# 11-38. TSF LEAKAGE RISK

Treatment of contaminants in the TSF is not presented in the EIS. The TSF is planned to be constructed on a fault. 1.6 ML/day of TSF leakage is planned without considering the fault risk. The planned monitoring places few controls on compliance with the design and there is no contingency plan to remediate leakage. No peer review of contamination risks has been presented.

Figure 1: Indicative design of conceptual seepage collection pond(s). Source – Figure 18 of (ATC Williams, 2020)

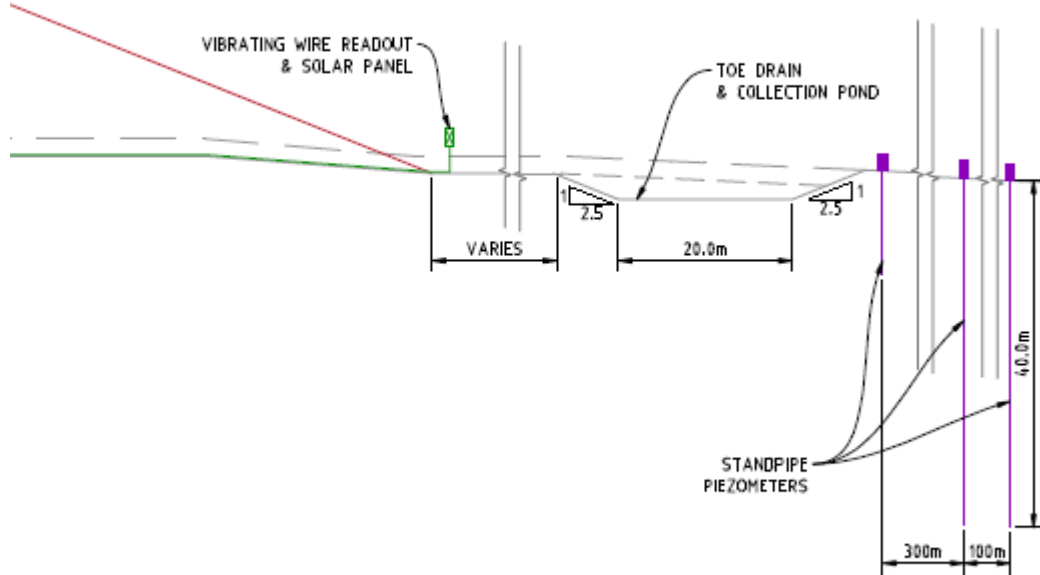
26). While the trigger for action is not stated, the proposed 'contingency' is to build more seepage collection down gradient.

The indicative seepage collection infrastructure (Figure 1) is valid for a small area due west of the TSF (see Figure 2).

Figure 2: Four planned piezometers for leakage monitoring. Source - Figure 17 (ATC Williams, 2020)

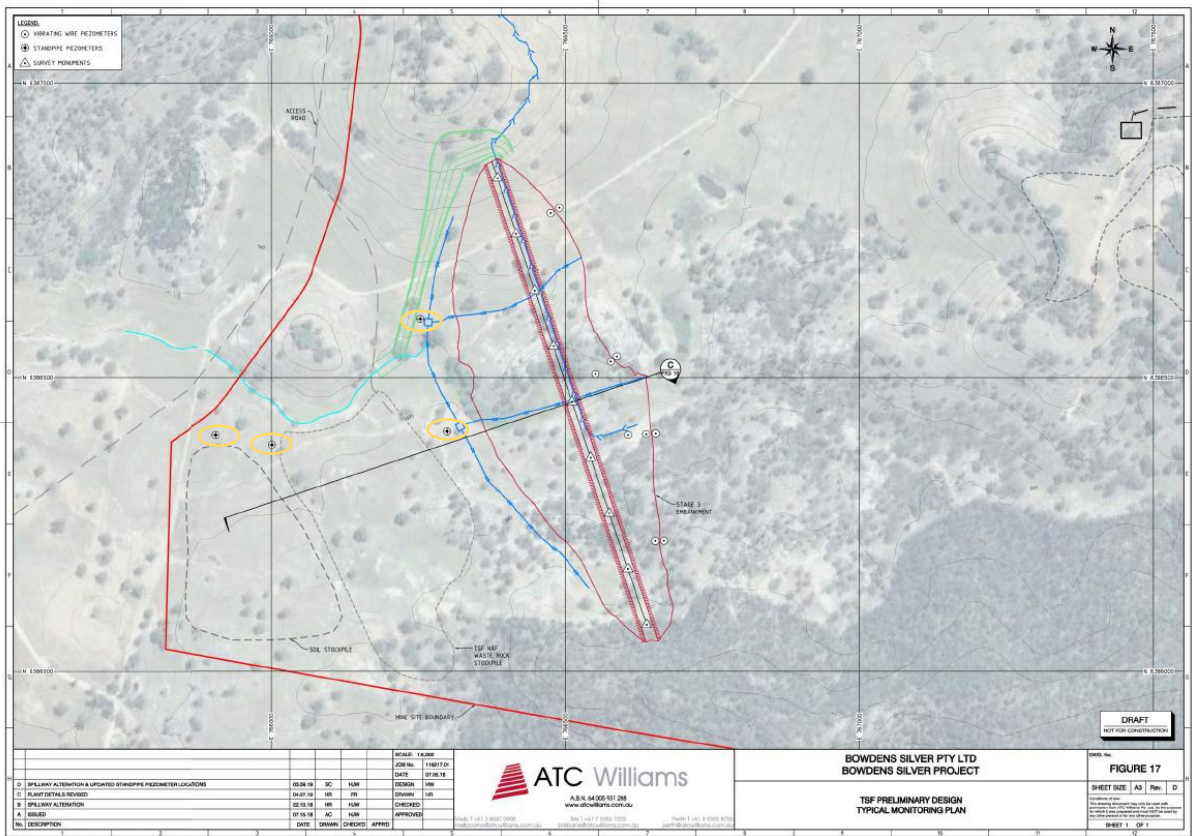
To calibrate this estimate, four standpipe piezometers are proposed near the embankment. None are listed around the TSF to detect leakage towards Lue Village or to monitor leakage into the pit lake.

Figure 3: Structural geology – adapted from Figure 11 of (Jacobs (Australia), 2020, pp. 5-57)

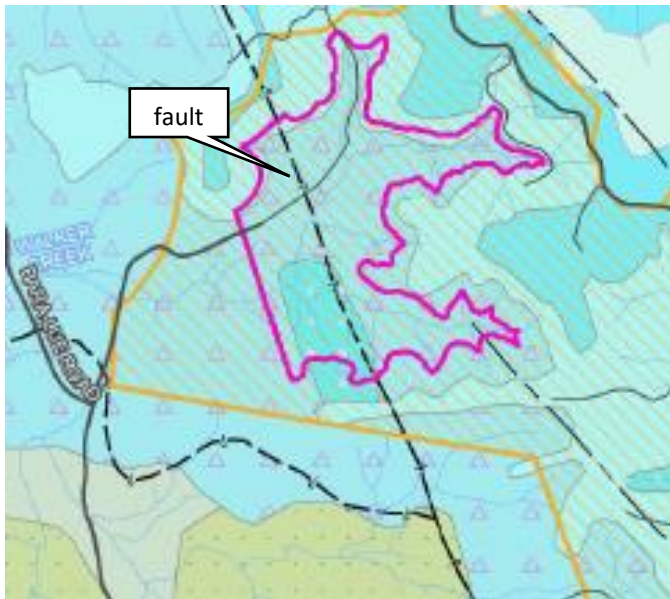
Faults have the potential to readily transmit large quantities of groundwater. The only reference to the faults mapped beneath the planned TSF is on page 2 of ATC Williams (2020). ATC Williams (2020 p.2) suggest leakage through faults (Figure 3) is considered in 'Section 7'. Transmissive faults can form a highly transmissive underground flow conduit in a preferred direction, potentially to a significant receptor. No reference to faults

can be seen in Section 7 and the TSF design and monitoring plan in ATC Williams (2020) does not appear to consider the leakage risk posed by faulting (ATC Williams, 2020).
